Report of the Review Panel
SKA Signal Transport and Networks
Concept Design Review
June 28-30, 2011

Figure 1

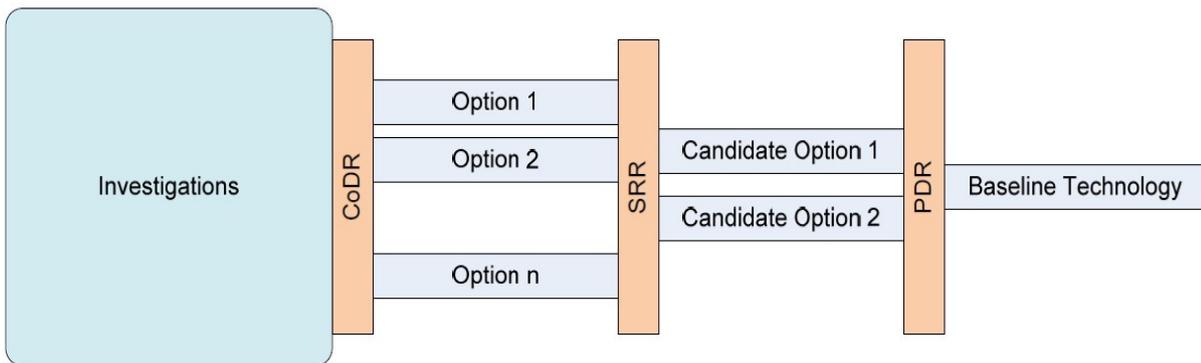
As shown in Figure 1, the STaN plans to take forward a number of potential solutions to the Sub-System Requirements Review Phase. The completion milestone of the Sub-System Requirements is a review, (STaN-SRR). It is believed that the decision to reduce the set of Candidate Options will be presented at that review.

The Panel observed that some of the presented material looked like results from existing projects, so it was not clear which of the options were to be carried forward. During the feedback, however, it seemed that all the presented options were potential candidates and are likely to be carried forward.

The STaN domain should aggregate similar options and then obtain clear statements of the cost, risk and feasibility options and put together plans to pursue these options. Parameterized models should be assembled to allow a rapid response to project wide decisions such as site or array configuration selections.

The Panel is concerned that carrying forward too many options could be counterproductive. There are also concerns about the efficiency of the collaborative process. The Panel feels that it would be desirable to reduce the number of options as early as possible and that this could be achieved through encouraging collaborations that will allow the merging of some options. The SPDO should provide leadership in this area.

Recommendation 5: The project should carry out a review of the various options being considered for carrying forward, reduce the number if possible, and merge the effort contributed to very similar options into more cohesive single efforts. This should be done in parallel with the steps outlined in Recommendation 1:.
